TECHNICAL BULLETIN

MODEL/DERIVATIVE:
Range Rover

Bulletin N°: 0084
CDS. ref: L8684bu
Issue: 1
Date: 12.12.01

DOOR MIRROR VIBRATION

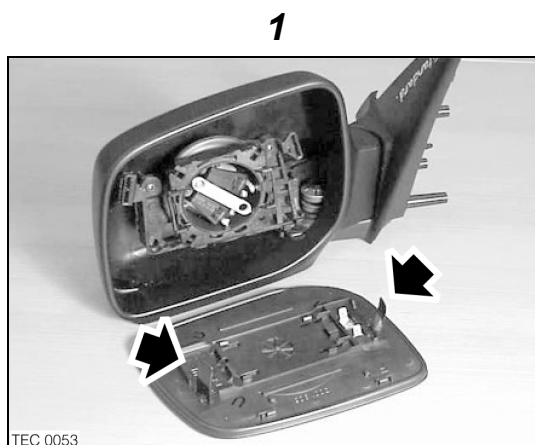
The door mirror glass vibrates and distorts rearward vision.

Insufficient internal damping of the door mirror assembly.

Where a complaint of the above is confirmed, replace the door mirror assembly and glass with the new specification parts detailed in *PARTS INFORMATION*.

1. Remove the door mirror assembly, refer to Workshop Manual, Chassis and Body, Exterior Mirror, repair number 76.10.52.

2. Paint new door mirror assembly if required.
3. Fit the new door mirror assembly, refer to Workshop manual, Chassis and Body, Exterior Mirror, repair number 76.10.52. Tighten door mirror assembly screws using the following sequence,
 - 1st – front lower
 - 2nd – top
 - 3rd – rear lower

Note: Any visible gaps between the mirror base moulding and the door should be filled with polyurethane sealant to eliminate possible wind noise. Clean off all traces of excess sealant.

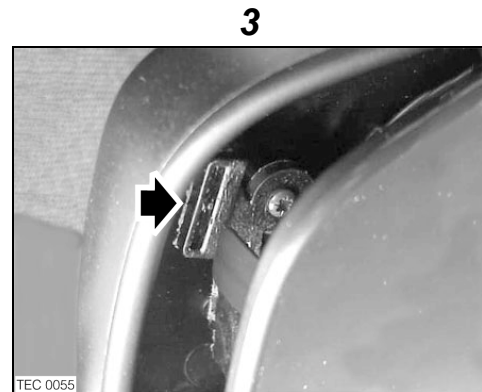
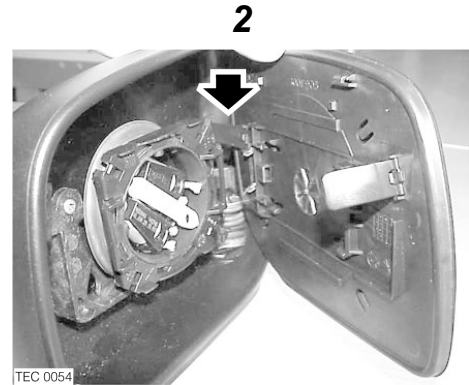
4. Select appropriate new glass for door mirror assembly.
5. Lift damper blades (arrowed in illustration 1). The blades should be positioned at right angles to the glass back plate.

6. Move the glass motor manually within the door mirror assembly so the inboard end of the motor is fully extended.
7. Position the glass to the door mirror assembly and connect the 2 heater Lucars.
8. Locate the inboard end of the glass onto the glass motor plate, ensure the inboard damper blade locates in the door mirror assembly slot, (arrowed in illustration 2).
9. Press on the glass to move the motor so that the outboard end is fully extended, locate the outboard damper blade in the door mirror assembly slot, (arrowed in illustration 3). Press the glass fully onto the glass motor plate.
10. Check the glass is fully retained and both dampers are located.
11. Check full operation of the door mirror assembly.

When replacing the glass only, on vehicles to VIN 2A 461981 and vehicles with Electrochromic door mirrors, only one damper needs to be located. Remove the inboard damper on LH door mirror assemblies and the outboard damper on RH door mirror assemblies. To remove the unused damper, fold the damper down against the backplate and release it from its retaining slot.
